Service Bulletin

Bulletin No. 2010-68
CMD 2010-08

Leak at Discharge Seacock—Zeus Pod

- Discharge seacock mounting surface**
- a -** Seacock counterbore with 54 mm (2.125 in.) diameter
 - b -** Seacock counterbore with 63.5 mm (2.50 in.) diameter

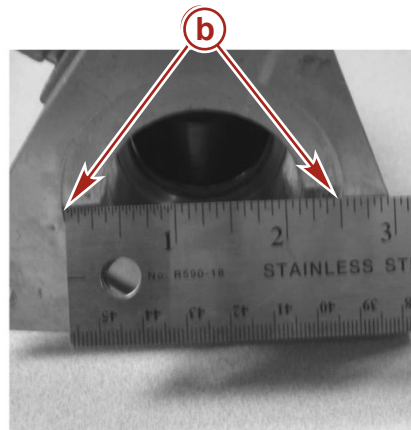
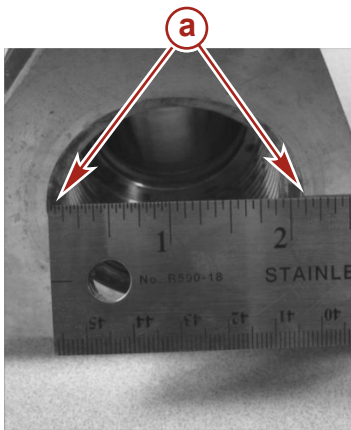
Discharge seacocks with a counterbore diameter of 54 mm (2.125 in.) as shown on the left in the picture below do not need to be replaced.

Discharge seacocks with a counterbore diameter of 63.5 mm (2.50 in.) as shown on the right in the picture below must be replaced.

For complete seacock removal and replacement procedures, refer to **Cummins MerCruiser Diesel Service Manual #52—Zeus 3000 Series Pod Drives**.
